breakaway creek inc.

Retro '64 Schematic

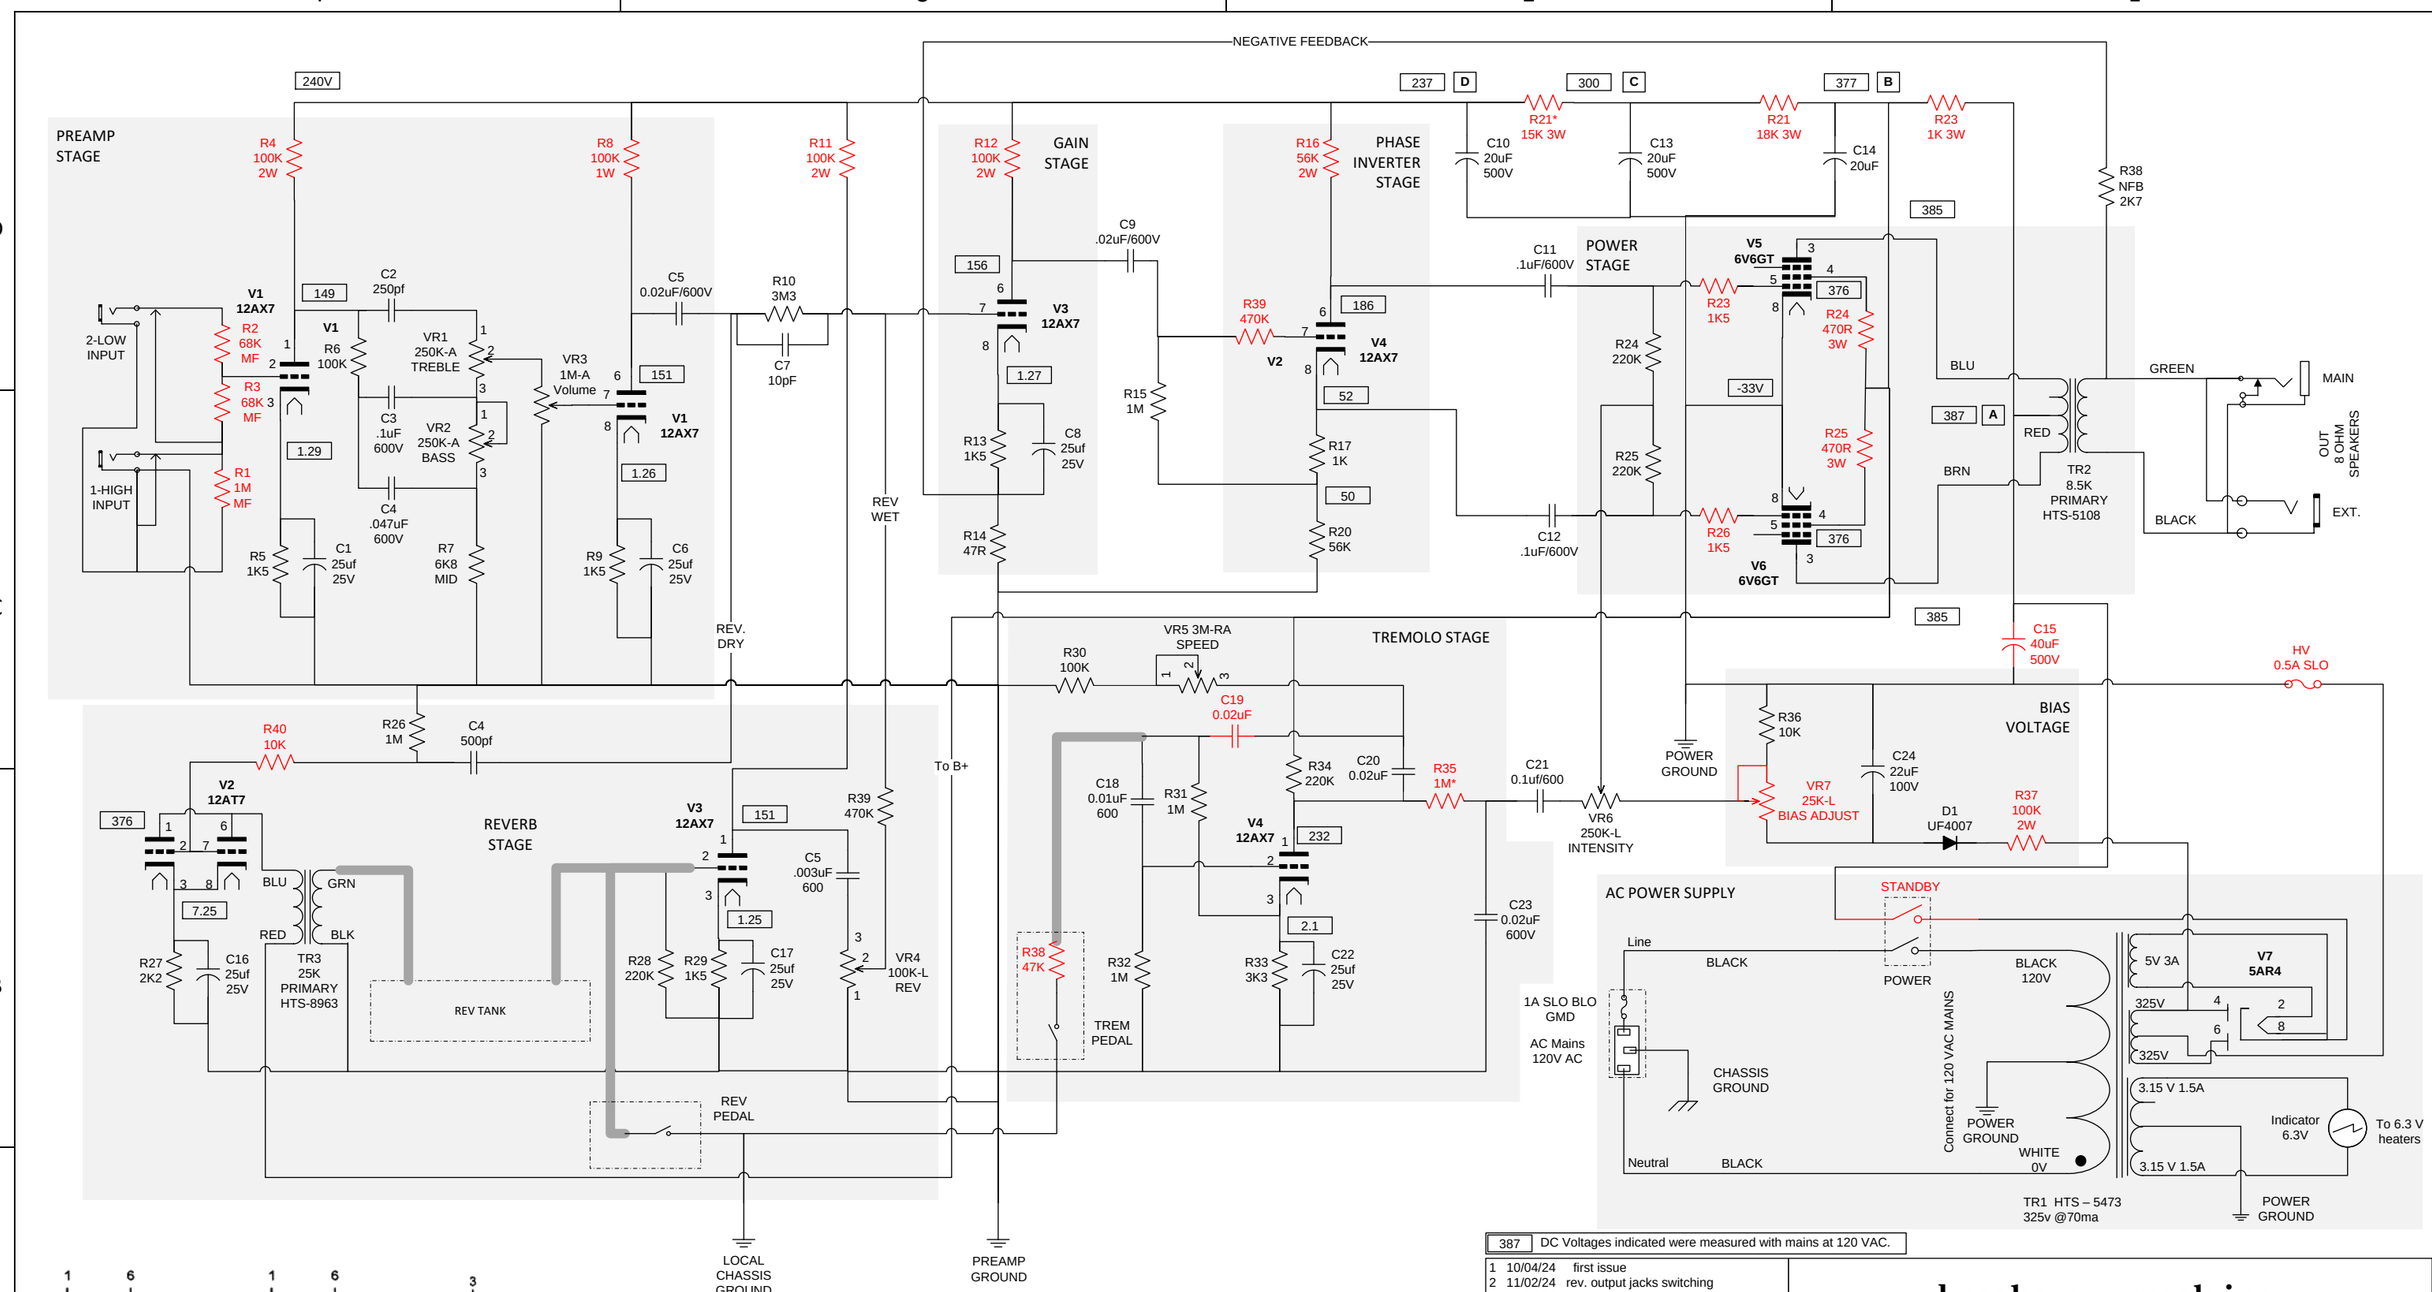
1	10/04/24	first issue
2	11/02/24	rev. output jacks switching
3	11/12/24	added R40, 10K to grid V2
4	12/16/24	updated to 100K 2W & 56K 2W
5	12/20/24	corrected VR7 connections
6	12/31/24	changed HV fuse location to PT- CT
7	01/16/25	changed bias filter cap to 22uF; added note for R21; voltages updated; reduced R21 to 15K
8	03/18/25	corrected ground for REV. F.SWITCH
9	01/21/26	removed V2 label on PI
